FJC | Melrose Park South - East Precinct Block 6 - SSDA Drawing Set Response to Submissions (RTS)

MELROSE PARK SOUTH | EAST PRECINCT BLOCK 6
DARUG
MELROSE PARK - BLOCK B6
MELROSE NSW 2114

Sheet No.
2009

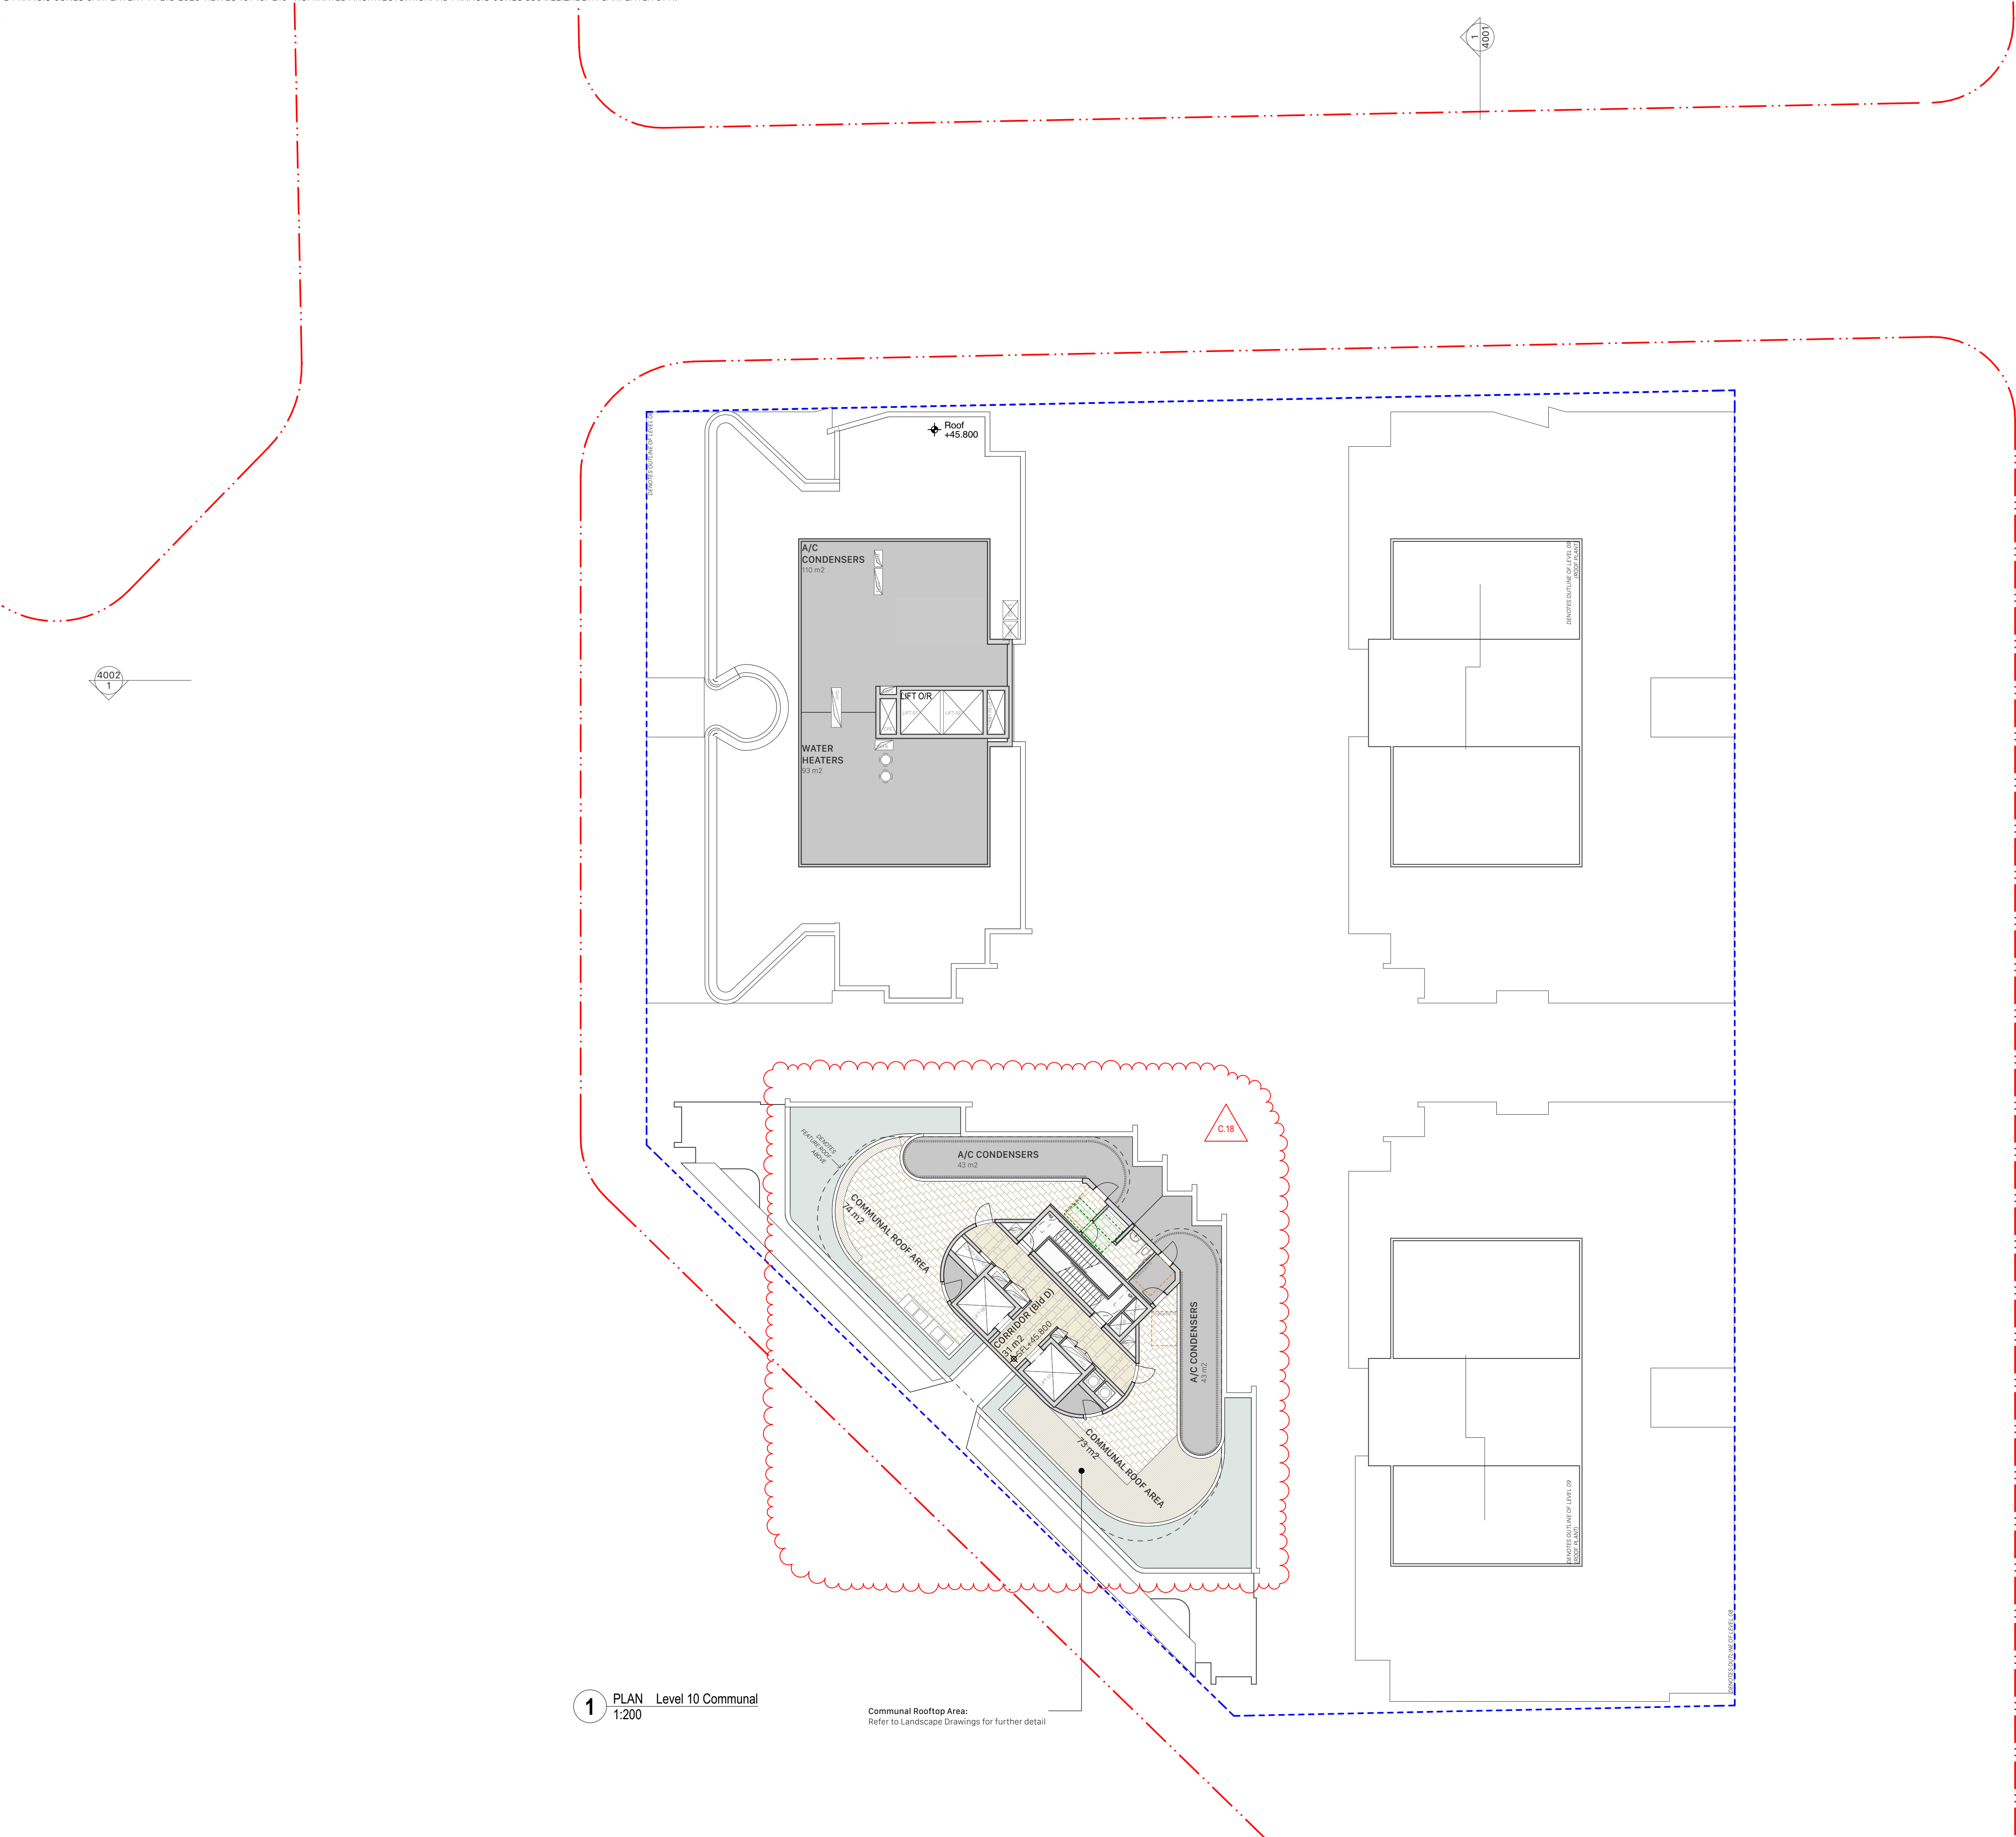
SUMMARY OF CHANGES (RTS)

C.10 WINDOW INTRODUCED TO PROVIDE NATURAL CROSS VENTILATION TO APARTMENT

Sheet No.
2010
Rev
C

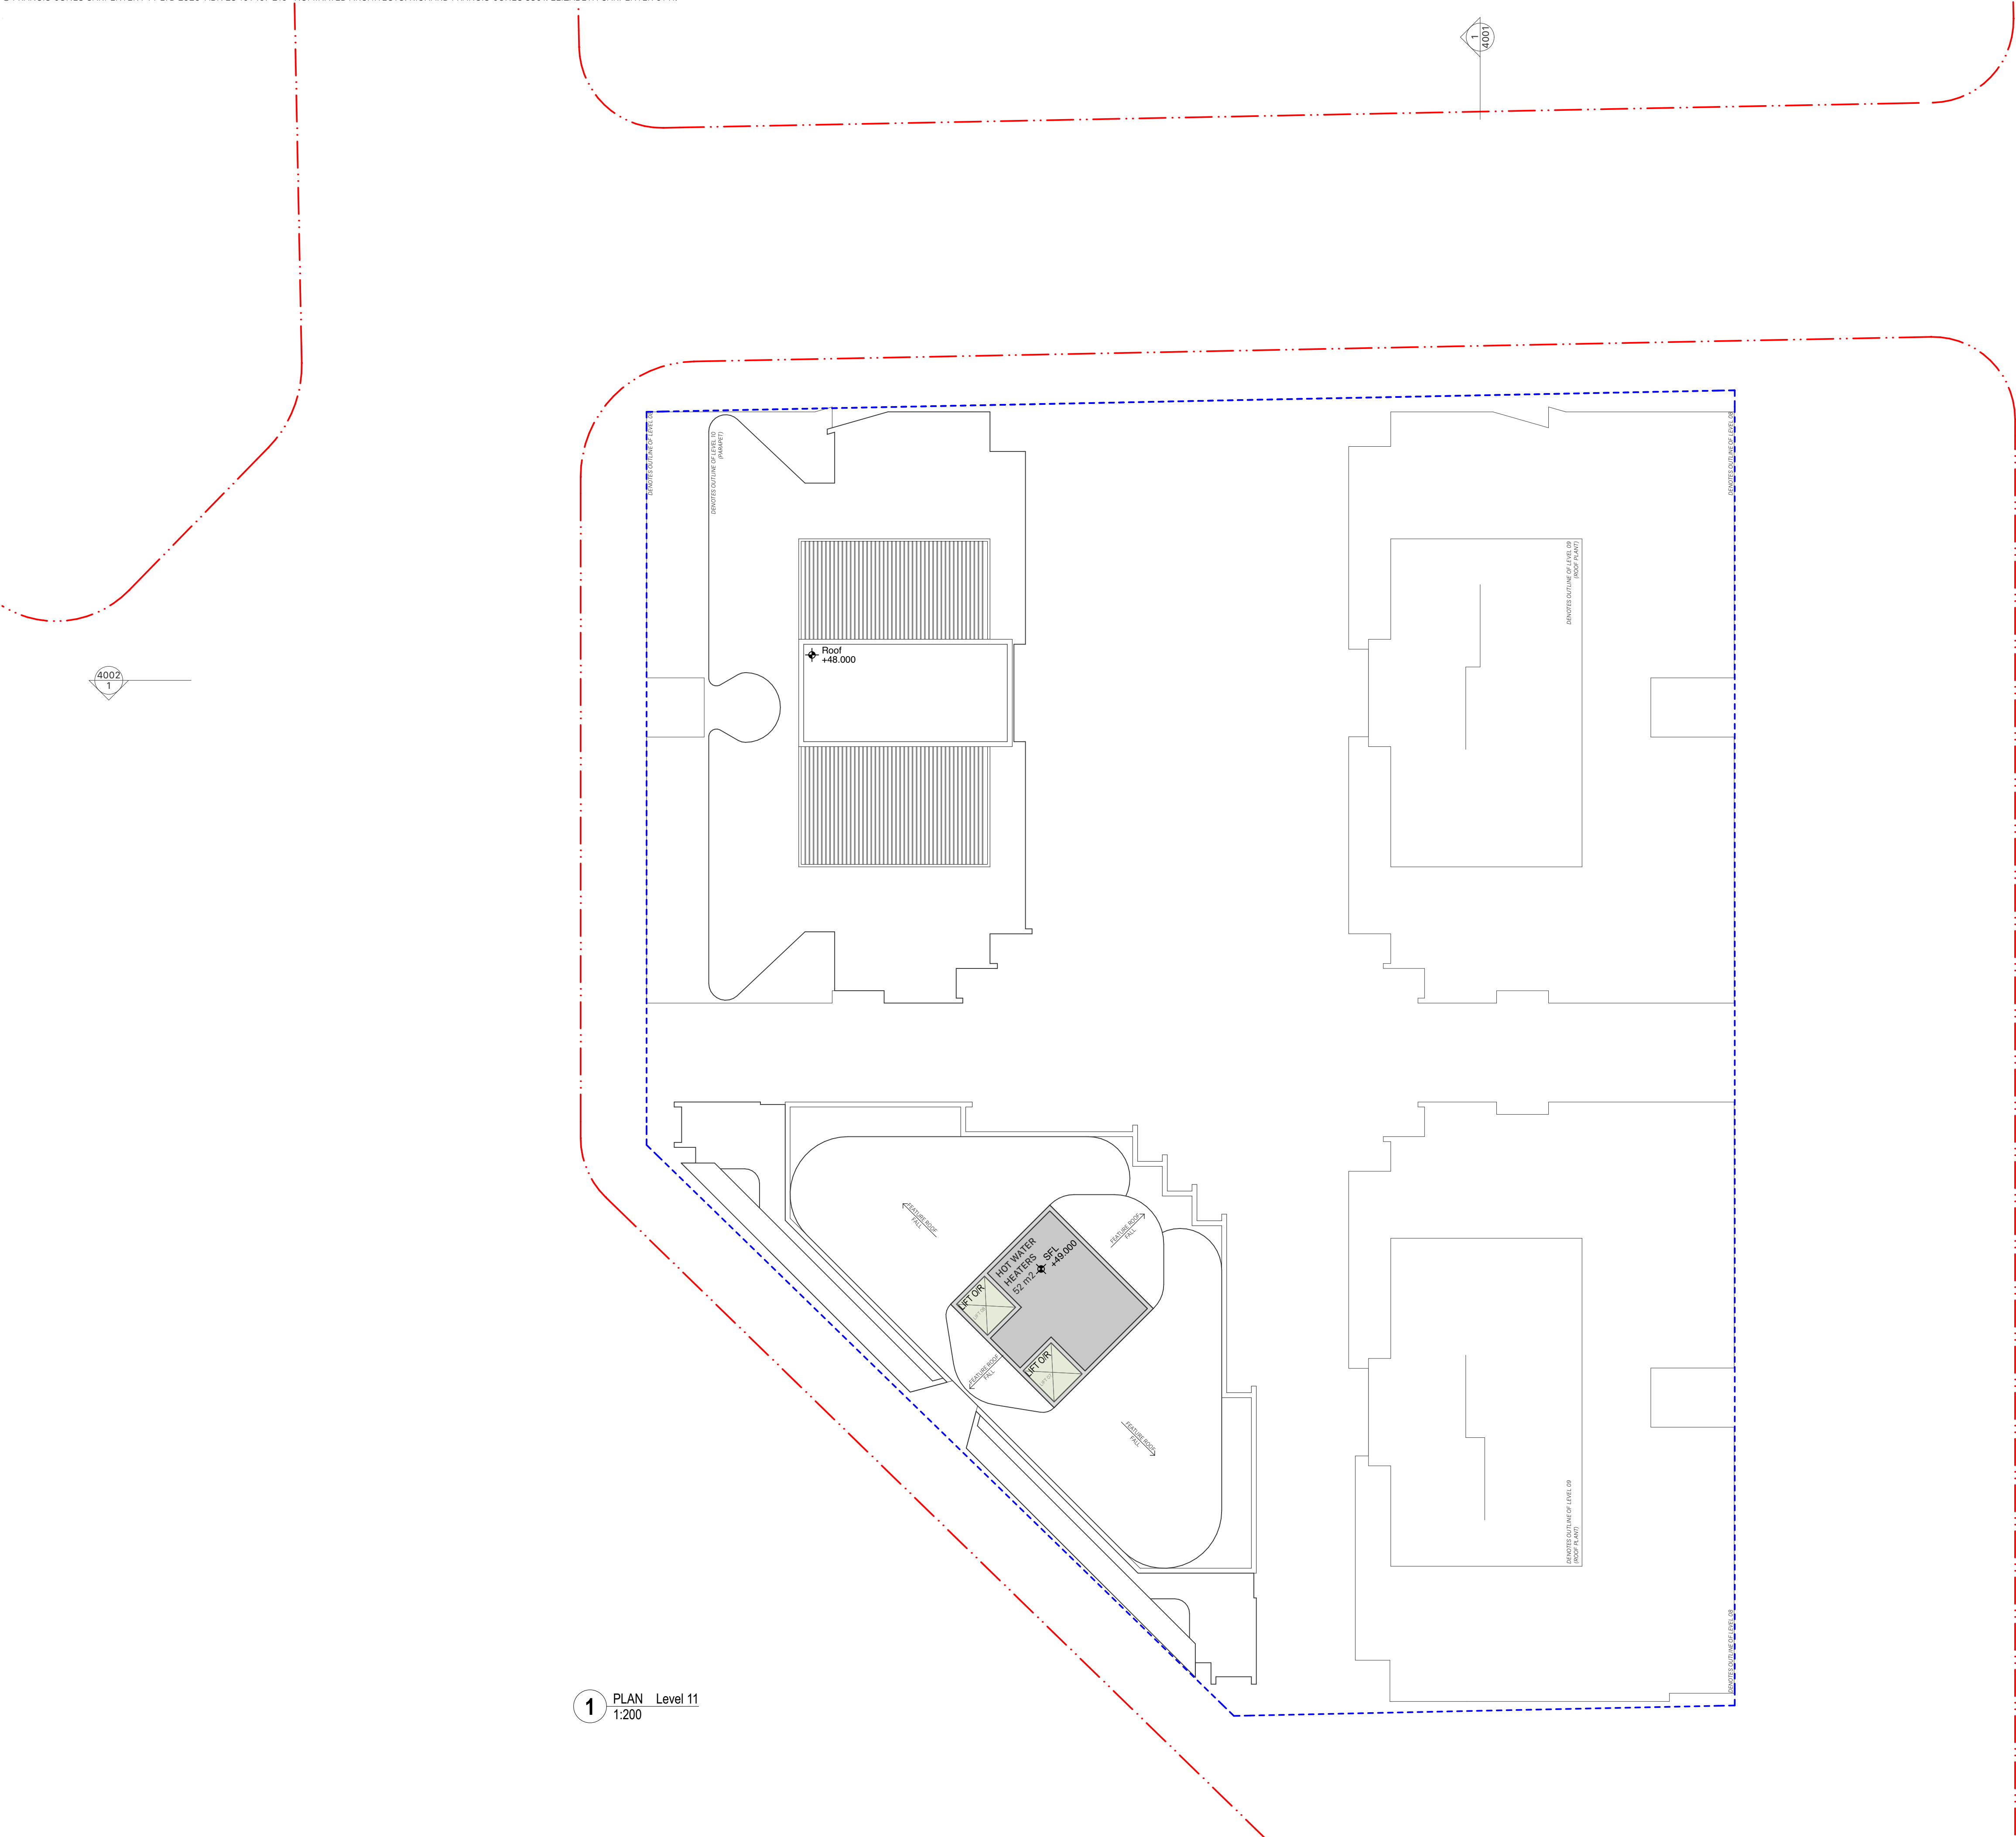
SUMMARY OF CHANGES (RTS)

C.18	COMMUNAL ROOFTOP AREA UPDATED TO ALIGN WITH ARCADIA'S LANDSCAPE DESIGN
------	--

Sheet No.
3102
Rev
C

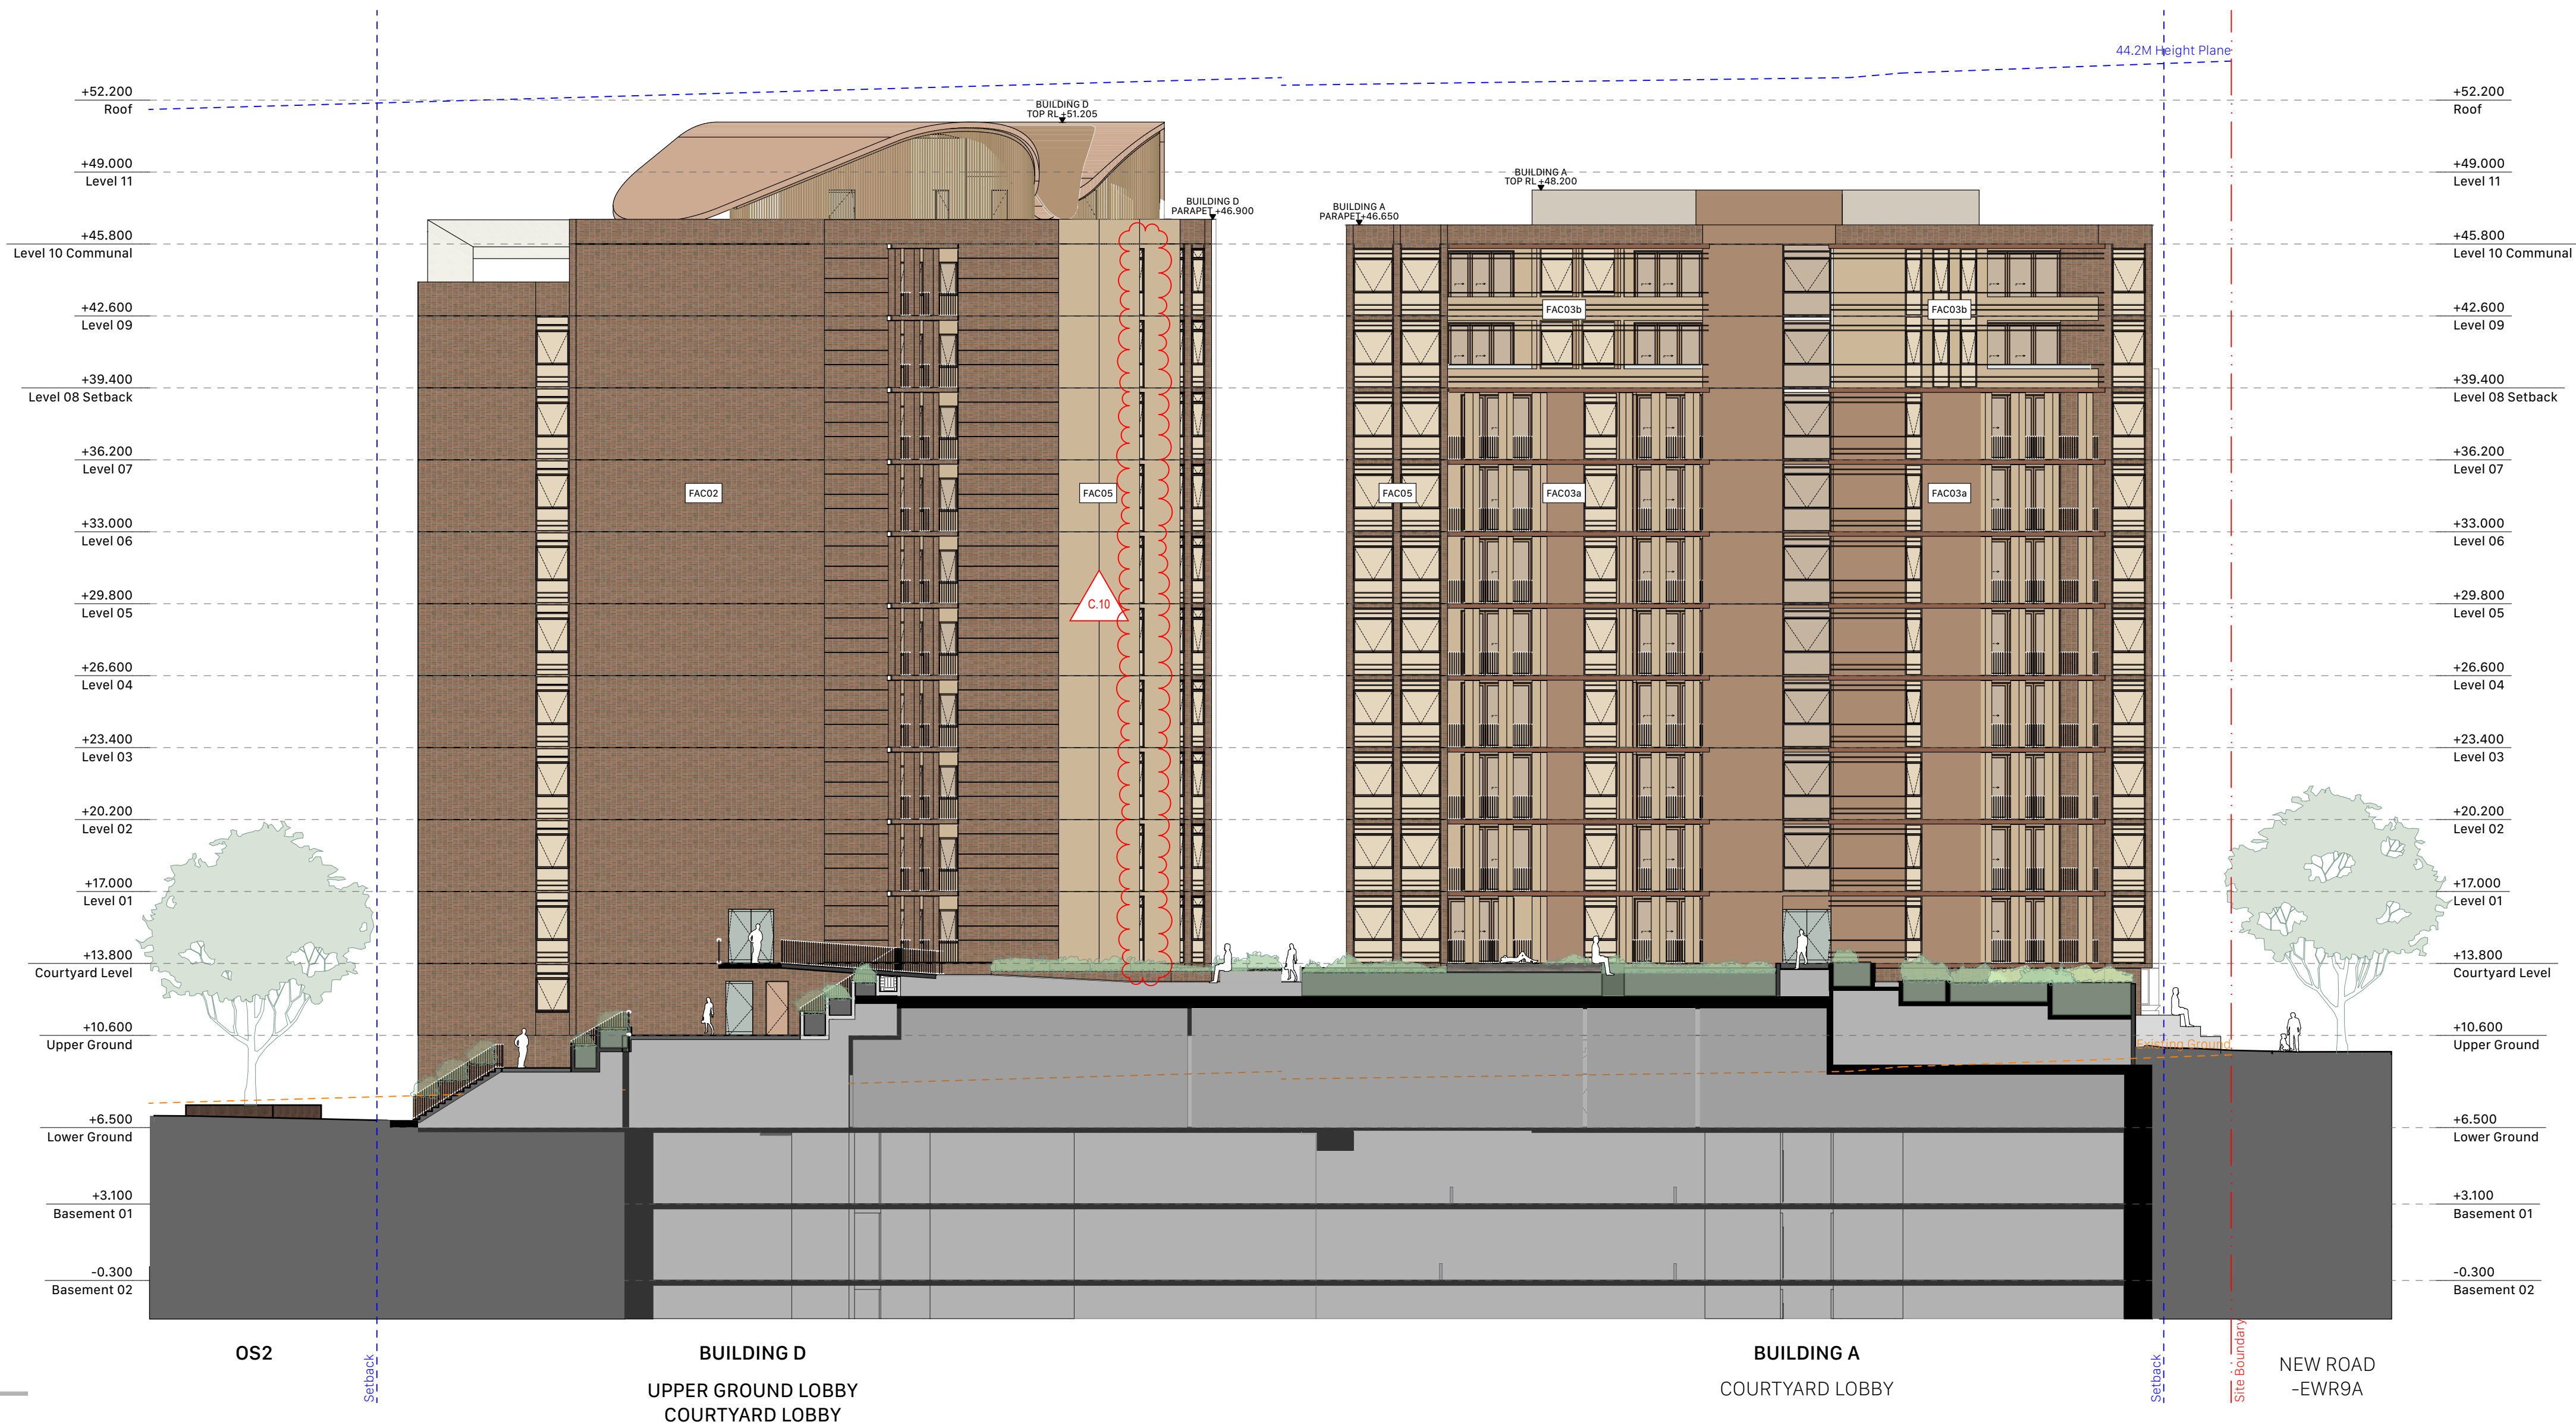
WINDOW INTRODUCED TO PROVIDE NATURAL CROSS VENTILATION TO APARTMENT
